MIXED USE DEVELOPMENT (APPLICATION NO 167.1/2023 PAN-333433
PROPERTY: BROOMFIELD STREET, CABRAMATTA
LANDSCAPE RESPONSES TO COUNCIL LETTER OF 1.12.2023 (COUNCIL RFI'S)

BROOMFIELD STREET CABRAMATTA
PREPARED BY: SITE IMAGE LANDSCAPE ARCHITECTS
ARCHITECT: PLUS ARCHITECTURE
FOR: MOON INVESTMENTS P/L
DATE: 12 FEBRUARY 2024

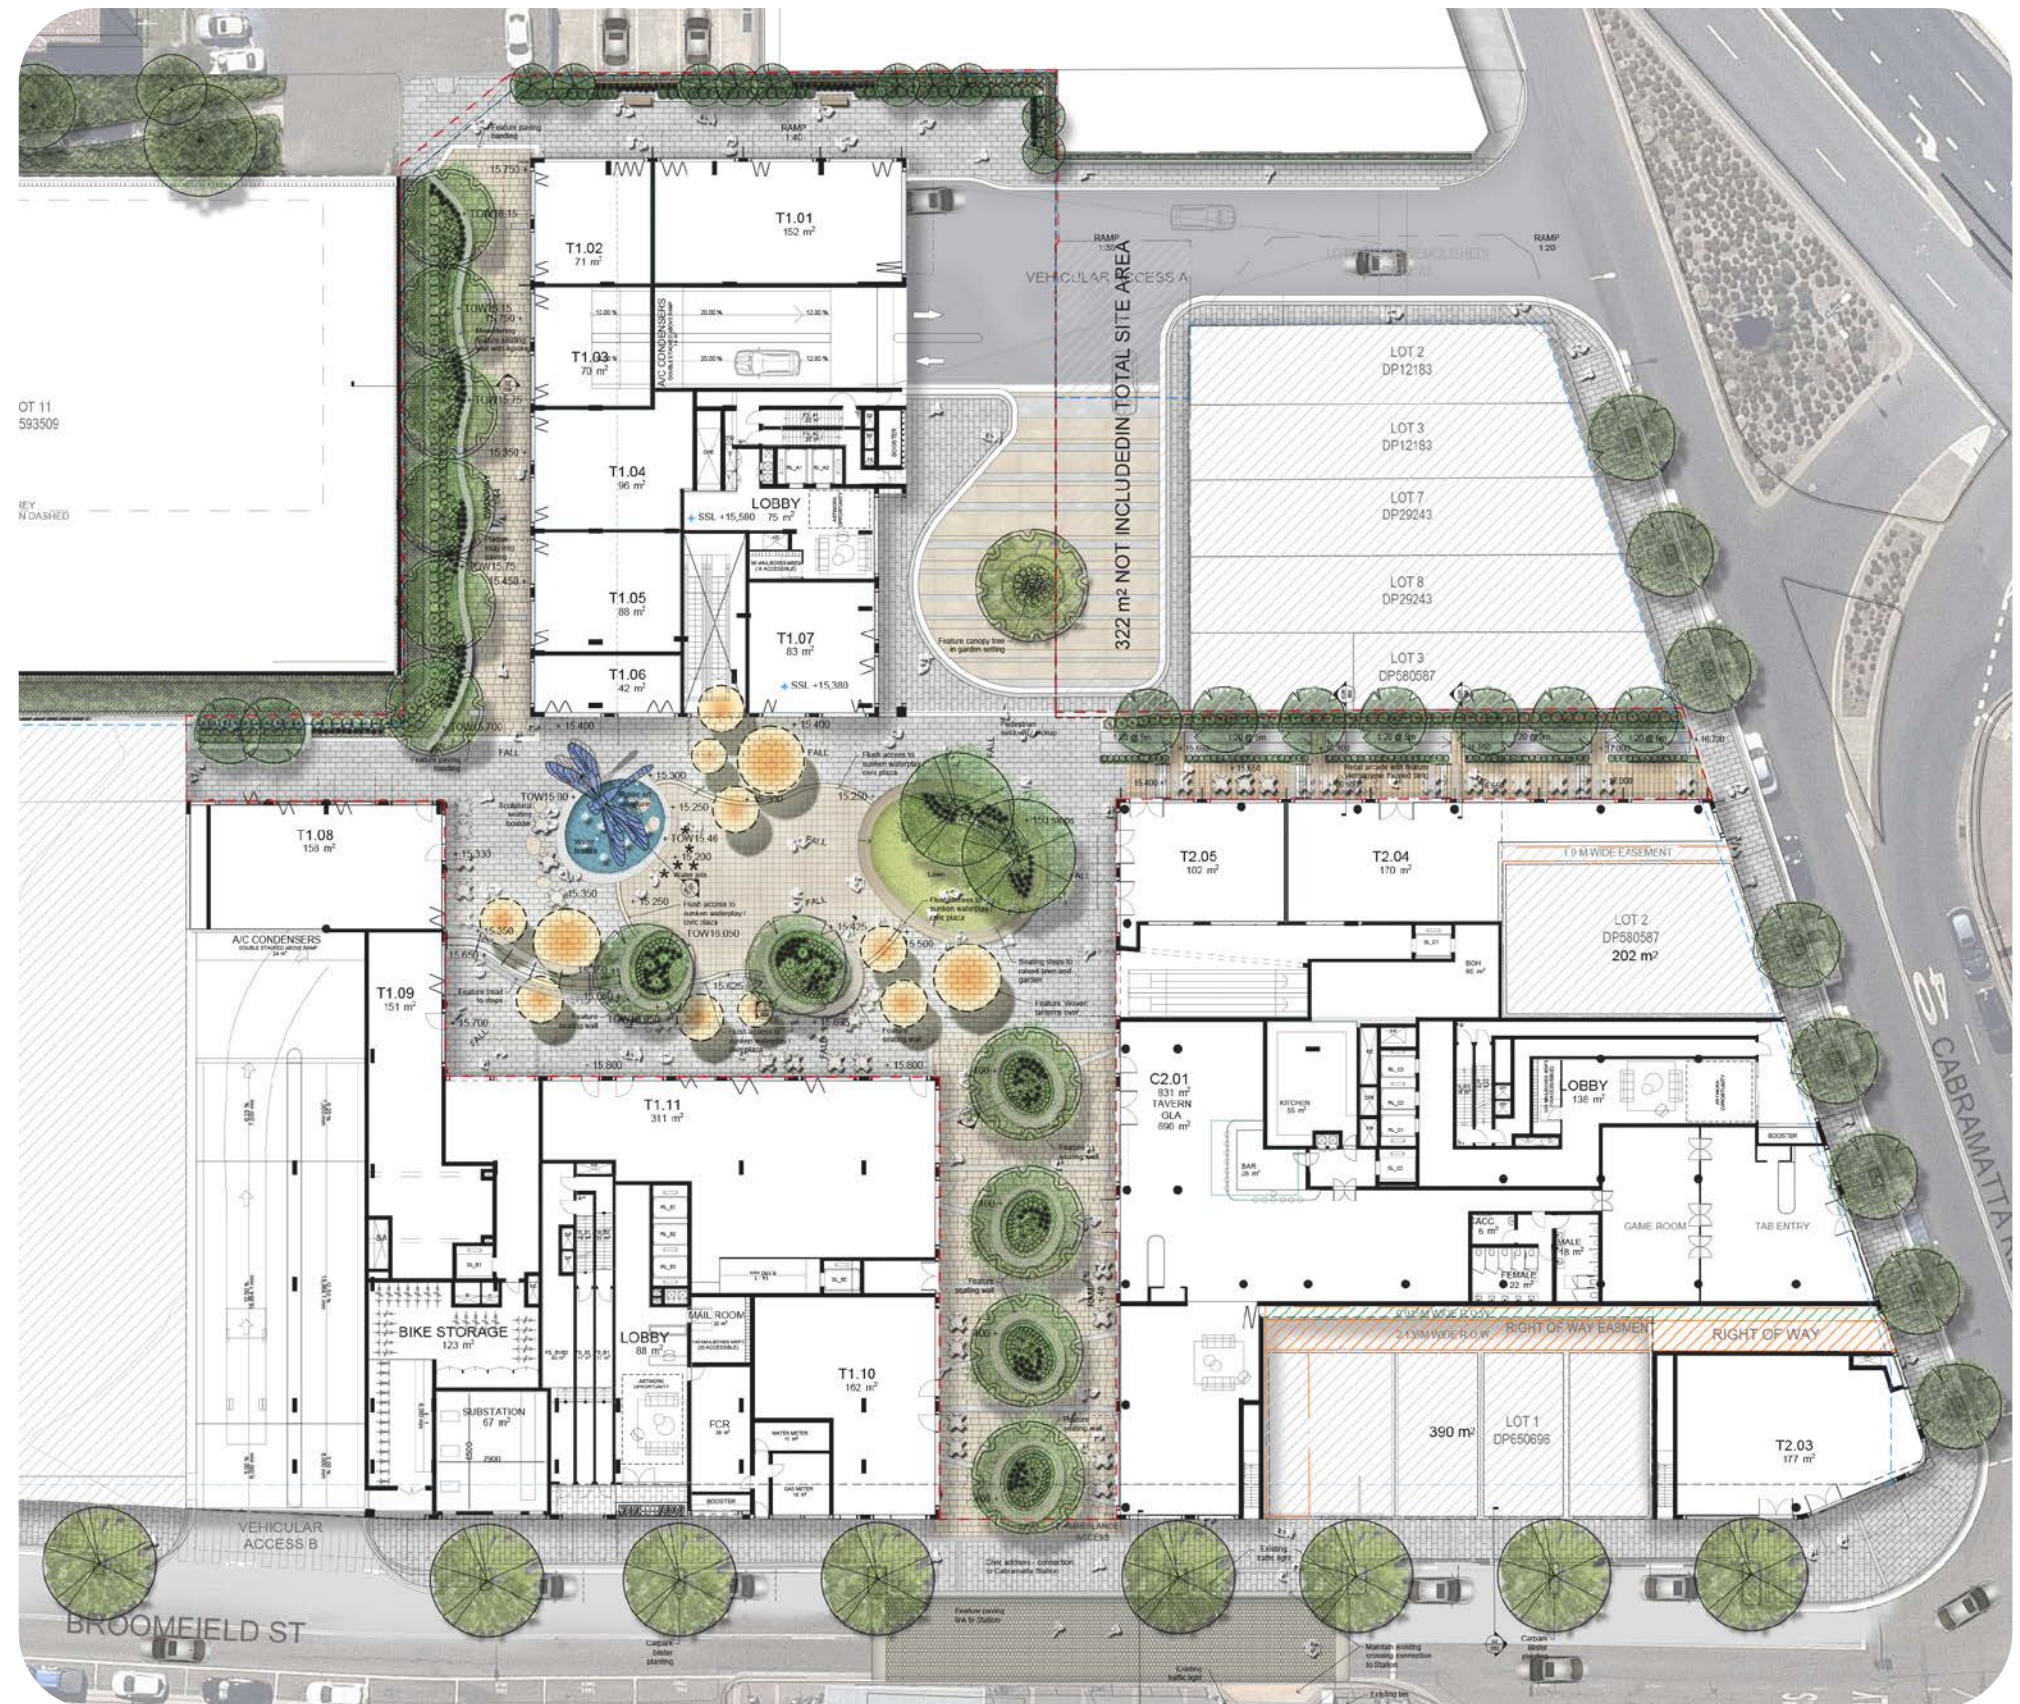
3. The development shall further contribute to the public domain by extending the landscape interventions into the adjacent space of the traffic islands. This extension would allow an overall uplift to the public domain in this area. This potential improvement is also listed as an objective for public domain improvement in Councils Public Domain Plan for Cabramatta.

Confirming that supplementary planting to complete / complement existing traffic island planters immediately south of the site will be undertaken to Council's requirements.
